RAIO-157505

SUBJECT: NuScale Power, LLC Response to NRC Request for Additional Information No. 005 (RAI-10089-R1) on the NuScale Standard Design Approval Application

Enclosure 1: NuScale Response to NRC Request for Additional Information RAI-10089, nonproprietary

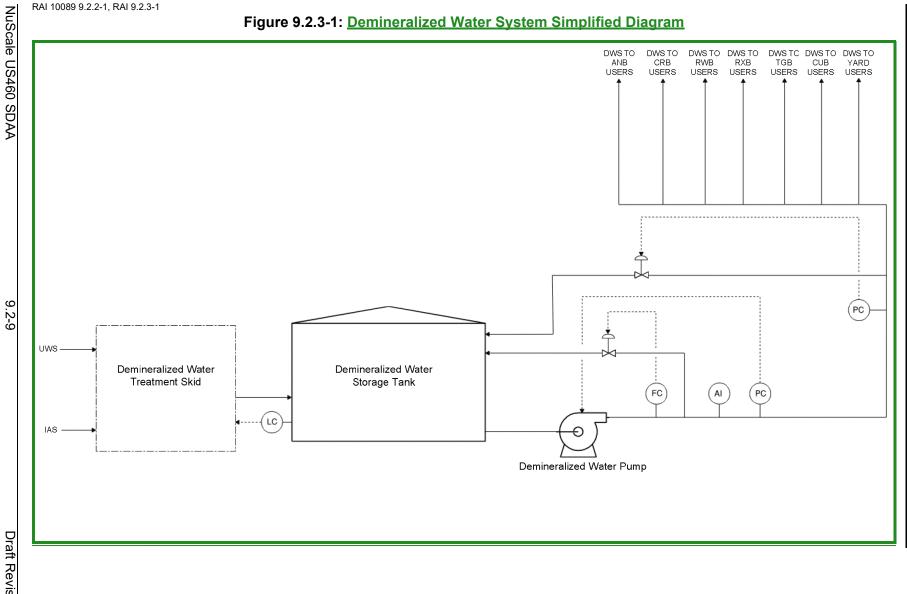
The staff reviewed the information provided in SDAA Part 2, Section 9.2.3 and determined that it does not fully satisfy this requirement because it does not contain sufficient information regarding the demineralized water system (DWS) necessary to obtain an understanding of the system design and operation. Specifically, Section 9.2.3 does not contain sufficient information on the system design, configuration, and operation to allow the staff to conclude that system failure will not adversely affect plant safety or radiological release from the plant during normal operation.

SDAA, Section 9.2.3.2 does not provide a description of the DWS system that would allow the staff to review the design against applicable NRC regulations. It does not contain system design information or what plant SSCs it supplies with demineralized water. In SDAA Section 9.2.3.3, "Safety Evaluation," it states that: (1) consistent with GDC 2, the design and layout of the DWS includes provisions that ensure that a failure of the system does not adversely affect the functional performance of safety-related systems or components; (2) consistent with GDC 2, portions of the system in proximity to Seismic Category I SSCs are designed to the Seismic Category II standard; and (3) Section 12.3, "Radiation Protection Design Features," provides information on the design features of the DWS that demonstrate compliance with 10 CFR 20.1406.

Since the FSAR contains no DWS system design information, does not give the location of SSCs in the DWS system, and does not specify what SSCs it services, the staff is unable to make a finding on the system ability to comply with GDC 2 or 10 CFR 20.1406.

The staff requests that NuScale provide and include in SDAA Section 9.2.3 the DWS design information, including a design description that identifies the systems that are serviced, a system flow diagram that shows the system functional arrangement and major components. Similar information that is being requested here was included in the corresponding sections of the design certification FSAR.

Section 9.2.3 of the SDAA provides design information for the Demineralized Water System (DWS). The information in this section includes a design description that identifies the system's major components and a simplified flow diagram that shows the system functional arrangement and flow distribution locations.

FSAR Section 9.2 has been revised as described in the response above and as shown in the markup provided in this response.

The DWS does not perform safety-related functions, is not credited for mitigation of design-basis accidents, and has no safe shutdown functions. Table 9.2.3-1 identifies SSC classifications for DWS. General Design Criteria 2 and 5, and 10 CFR 20.1406 are considered in the design of the DWS. <u>A diagram of the DWS</u> is provided in Figure 9.2.3-1.
